Yadkin Project Relicensing (FERC No. 2197)
Recreation, Aesthetics, and Shoreline Management Issue Advisory Group
May 3, 2005

Draft Meeting Summary

Yadkin Aesthetic Studies

Draft Reports

Figure 3-1
High Rock Water Level Alternatives

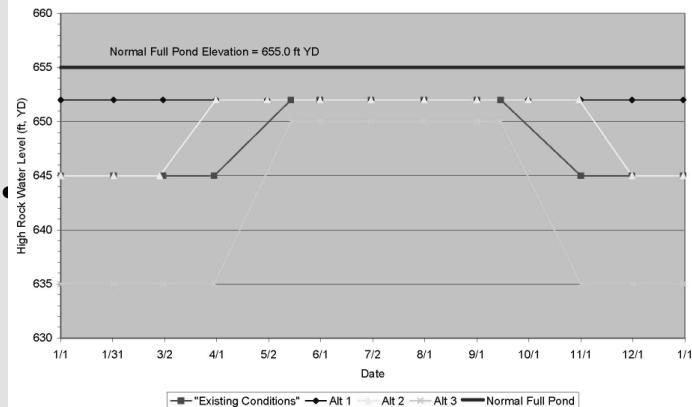
Larry Jones, High Rock Lake Association, questioned why the seasonal drawdown at High Rock Reservoir is considered “somewhat compatible” when “exposed lake bottom” is considered a scenic detractor by 49% of the survey respondents. David explained that the baseline for comparing the compatibility of the drawdown at High Rock with the surrounding reservoir area is the existing scenic integrity of the area (rated as low or moderately altered). Given this, ERM concluded that the drawdown is somewhat compatible to the moderately altered landscape around the reservoir (more than 2,000 waterfront homes and piers are concentrated along the

main body of the reservoir). Larry stated that it is wrong to conclude that it is okay (compatible) to draw the reservoir down since there are homes built around it. He questioned why a drawdown at Narrows is considered not compatible when it is just, if not more, developed than High Rock. Larry said that the number of homes per shoreline mile is greater on Narrows than High Rock. David explained that the distinction that he made between development on High Rock and Narrows was that development along High Rock is concentrated near the mainstem portion of the reservoir and Narrows appears less altered because a portion of the shoreline is undeveloped national forest. Larry commented that a drawdown at High Rock Reservoir should be considered incompatible from an aesthetics standpoint.

David Wright suggested that there is a problem with the compatibility determinations because two significantly different alternatives rated similarly (the existing condition and Alternative 2 both were rated somewhat compatible). He suggested that the compatibility determinations be more direct and specific (possibly month by month), so that the differences in the alternatives and the true impact of the alternatives on scenic quality become clearer (e.g. under existing conditions, there may be five months when Project operations are only somewhat compatible to the scenic integrity versus three months under Alternative 2).

Continuing, David concluded that the existing operations at High Rock and Alternative 2 (extended recreation season with a 10-ft drawdown) are somewhat compatible with the scenic integrity of the area, Alternative 1 (near full pool year-round) is compatible with the scenic integrity of the area, and Alternative 3 (a larger winter drawdown) is not compatible with the scenic integrity of the area.
